SAFETY EVALUATION REPORT

OFFICE OF NUCLEAR REACTOR REGULATION
SUPPORTING AMENDMENT 22 TO FACILITY
OPERATING LICENSE NO. DPR-34

PUBLIC SERVICE COMPANY OF COLORADO
FORT ST. VRAIN NUCLEAR GENERATING STATION
DOCKET NO. 50-267

FIGURE 2.1
POWER-TO-FLOW RATIO TECHNICAL SPECIFICATION
CURVE FOR FORT ST. VRAIN

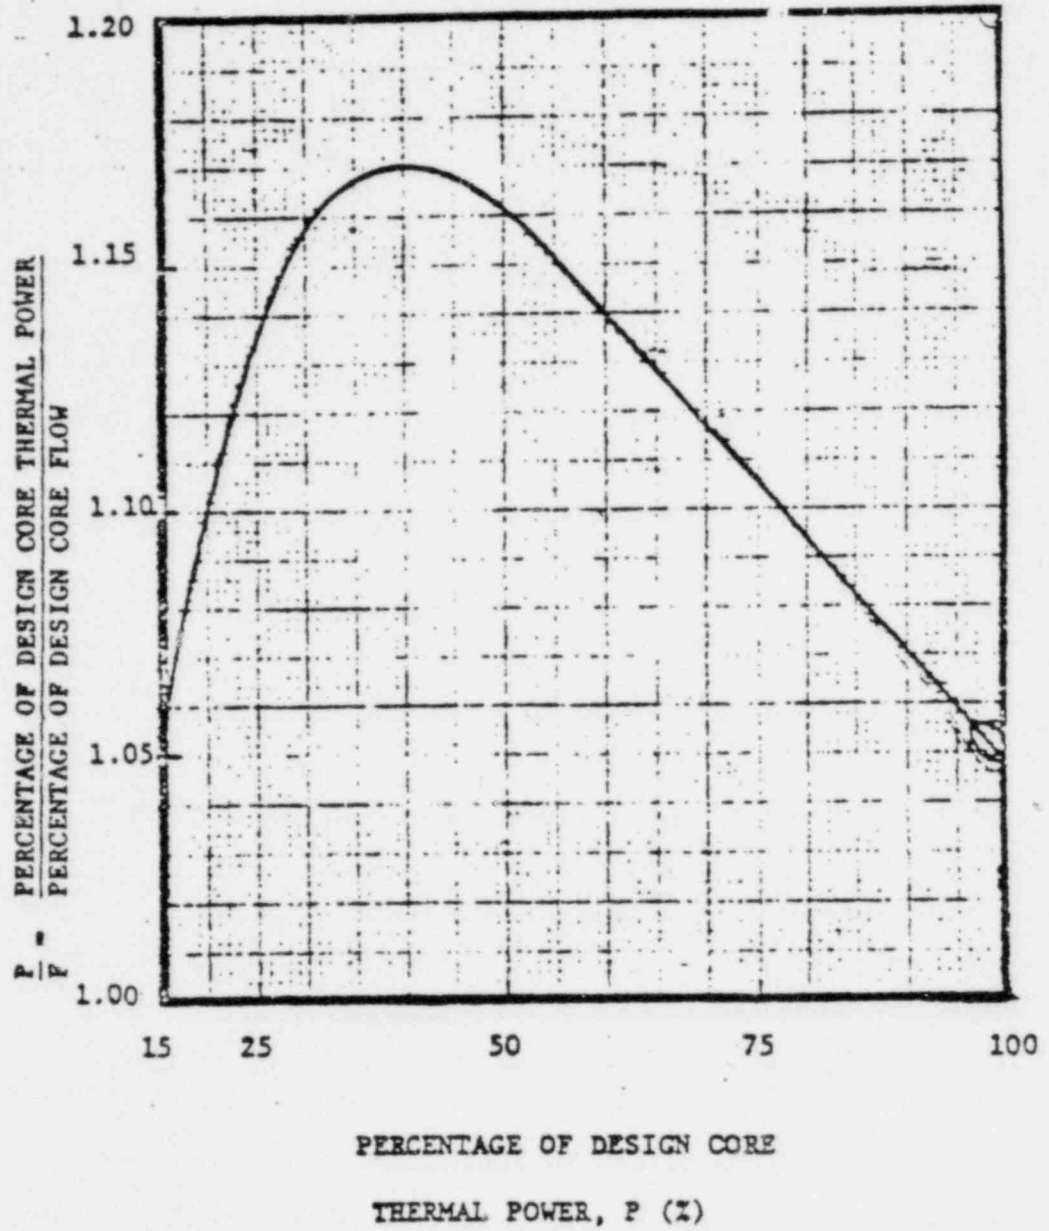
In our review of initial conditions with respect to the allowable power-to-flow ratios in the technical specifications, it was noted that for limited periods of time, the technical specifications allow full power operation at power-to-flow ratios greater than 1.05 based on steady state time-at-temperature limits for fuel damage. The licensee considers operation in this region to be a degraded plant condition and has stated that normal practice is not to operate with power-to-flow ratios greater than 1.05. Since operation in this degraded mode has not been considered in the accident reanalyses, deliberate operation at power-to-flow ratios in excess of the curve shown as Figure 2.1 (Figure 3.1-1 of the technical specifications) is not acceptable to the staff. If the power-to-flow ratio limits of Figure 2.1 are exceeded, we will require that the operator act promptly to bring the plant within

allowable limits. We will require the licensee to propose technical specification revisions to conform to this position prior to approval of 100 percent power operation.

FIGURE 3.1

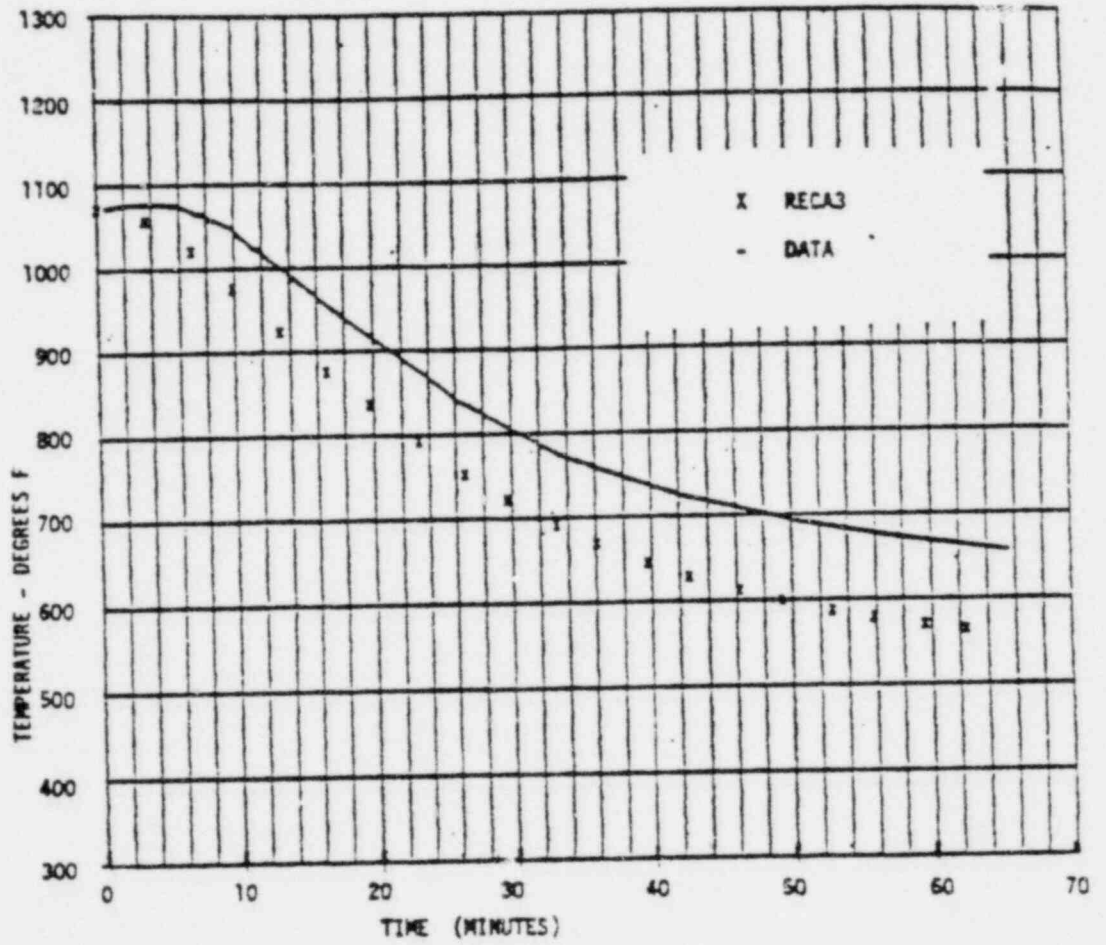
The RECA3 comparisons to available scram data indicate that predictions of helium temperature in the maximum peaking factor refueling regions are in good agreement with the measured temperatures. However, the code underpredicted helium temperatures in the north-west quadrant of the core by as much as 50°F to 100°F in the 40-70 second time frame as shown in Figure 3.1. This discrepancy may be due to excess bypass flow through fuel region gaps in this

quadrant. Such observations are consistent with region outlet temperature fluctuation phenomena observed during plant operation. The fluctuations were most prominent in this region, and are believed to be due to the opening and closing of axial gaps between fuel blocks.

The discrepancy between the predicted and measured region outlet temperatures is of concern to the staff. We will therefore require that the applicant perform at least one verification transient subsequent to corrective action taken to eliminate the core fluctuations. This transient can be a reactor trip from power, and the verification should consist of comparisons of measured to predicted region outlet temperatures. Acceptable* predictions of the measured data, including resolution of the previously observed northwest quadrant discrepancies, will be required before full power operation is allowed. Alternatively, the licensee should identify an acceptable operating power level, based on accident analyses in which this uncertainty has been properly accounted for.

FIGURE 3.2

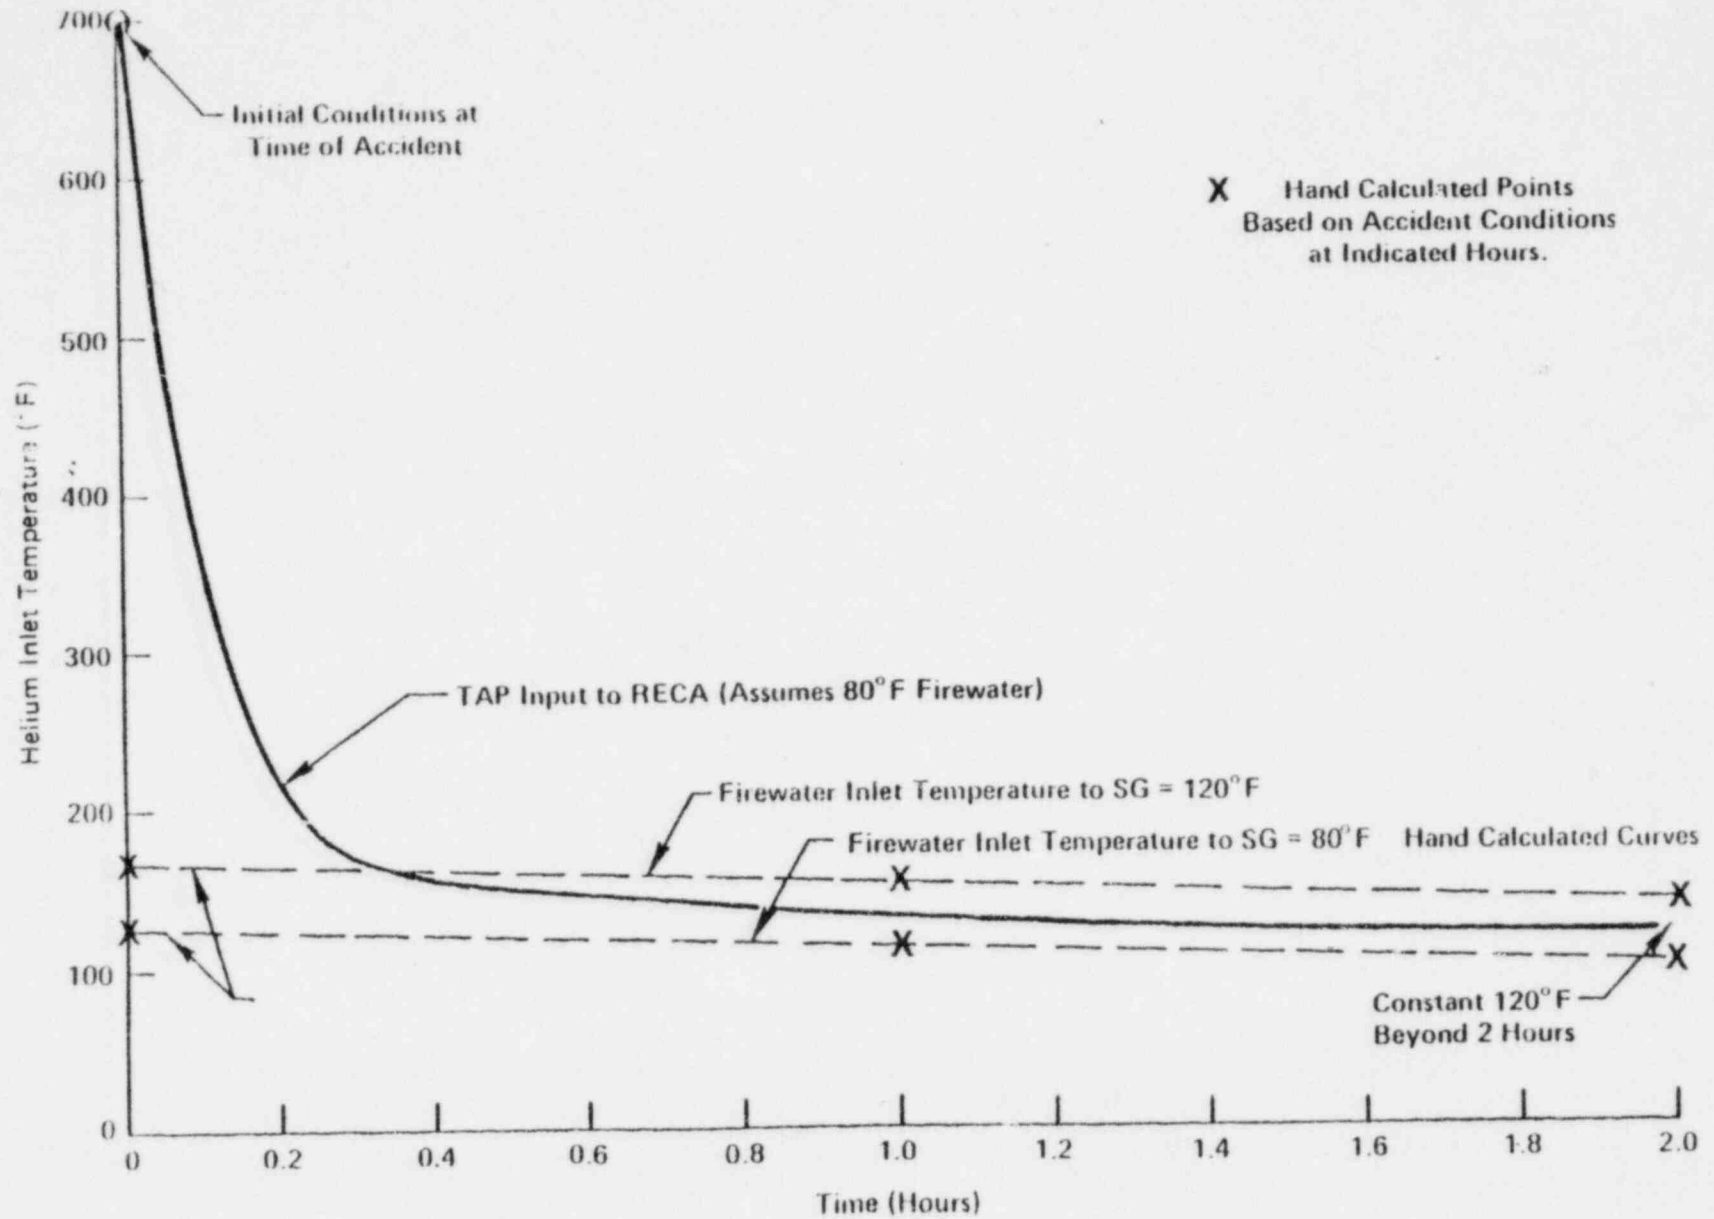
The TAP code is used to calculate the temperature of the helium exiting the steam generators and entering the upper plenum and core as input to the RECA3 calculations. Although the TAP code has not been verified against data, hand calculations were performed by the licensee to confirm the calculational accuracy of the TAP code. These comparisons are provided in Figure 3.2 and show the TAP calculations to be in good agreement with the hand-calculated values of helium inlet temperature.

the exit to the steam generators will be approximately the same as the feedwater temperature, and therefore should not be a highly sensitive parameter. Based on the above considerations and the confirmatory hand calculations, the staff finds the use of the TAP code acceptable for the purpose of calculating the helium temperature exiting the steam generator.
